Access Compliance Report

Public Rights-of-Way

(Curb Ramps)

Intersection ID: 29398	Main Street: FARNSWORTH_LN	Cross Street: GOLD_PAN_RD	Location: NE
ADA ID: A8288ED0AC99	Ramp Type: PerpDiag	Initial Pass/Fail: Fail	Overall Compliance: No
Severity Score: 33.75			
Codes/Mitigation Info/Possible Solution		Field Measurements/Component Compliance

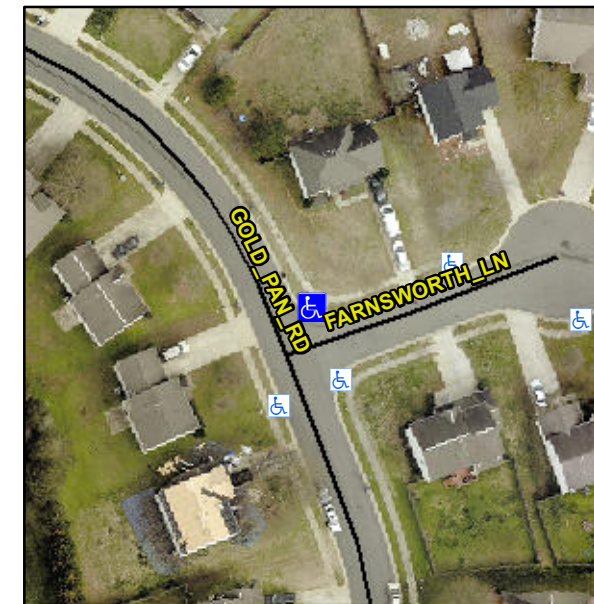
Not Found, R304.5.1, R304.5.3

Compliance	Description	Data	Compliance	Description	Data
N/A	Ramp Length (in)	75.5	Yes	Ramp Slope (%)	7.2
No	Ramp Width (in)	38.5	No	Ramp XSlope (%)	11.0
N/A	Flare Type LT	N/A	N/A	Flare Type RT	N/A
N/A	Flare Slope LT (%)	N/A	N/A	Flare Slope RT (%)	N/A
N/A	Flare Traversable LT?	N/A	N/A	Flare Traversable RT?	N/A
N/A	Landing Length (in)	N/A	N/A	DWS Provided?	N/A
N/A	Landing Width (in)	N/A	N/A	DWS Contrast?	N/A
N/A	Landing Slope (%)	N/A	N/A	DWS Length (in)	N/A
N/A	Landing X Slope (%)	N/A	N/A	DWS Full Width?	N/A
N/A	Landing Curb? (Y/N)	N/A	N/A	DWS Offset (in)	N/A
N/A	Shared Landing?	N/A			
N/A	Gutter Ponding?	N/A	N/A	Gutter Slope (%)	N/A
N/A	Gutter Lip Ht (in)	0.5	N/A	Gutter X Slope (%)	N/A
N/A	Painted X Walk1?	No	N/A	Painted X Walk2?	No
	X Walk 1 Direction	To W		X Walk 2 Direction	To S
N/A	X Walk 1 Width (in)	N/A	N/A	X Walk 2 Width (in)	N/A
	X Walk 1 Slope (%)	8.4		X Walk 2 Slope (%)	2.6
	X Walk 1 X Slope (%)	6.4		X Walk 2 X Slope (%)	7.1

N/A	Ramp inside XWalk1?	N/A	N/A	Ramp inside XWalk2?	N/A
	Road Slope (%)	8.6	N/A	Clear Space?	N/A
	Road X Slope (%)	1.8	N/A	Clear Space to XWalk (in)	N/A
N/A	Any Obstructions?	N/A	N/A	Storm Grate/Utility Hazard?	N/A
	Obstruction Type			Storm Grate/Utility Type	
		N/A			N/A
		Yes		Surface Condition? (G/P)	Good

Remove & Replace Curb Ramp With Two New Directional Ramps or Equivalent.
